# ENDL TEXAS

Date: 9 June 2008  
 To: SNIA OSD TWG and T10 Technical Committee  
 From: Ralph O. Weber  
 Subject: OSD-2 CDB Continuations Definition and Usage

Figure 4 — OSD security model transactions

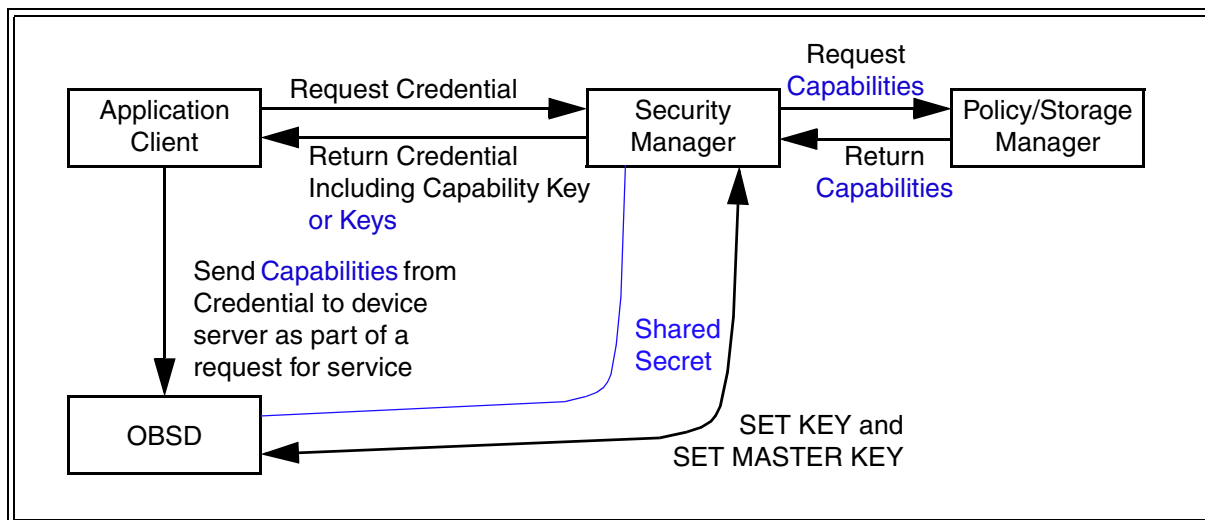
The principal function of the security manager is preparing credentials (see 3.1.11) in response to application client requests. A credential is a data structure containing ~~a capability~~ one or more capabilities prepared by the policy/storage manager (see 4.11) and protected by ~~an integrity check value~~ one or two integrity check values (see 3.1.19), having the following properties:

- The capability or capabilities (see 3.1.4) in the credential ~~grants grant~~ defined access to an OSD logical unit for specific command functions (see 3.1.10); and
- The integrity check ~~value values~~ in the credential ~~protects protect~~ the ~~capability capabilities~~ and commands that include the ~~capability capabilities~~ from various attacks described in 4.12.4.
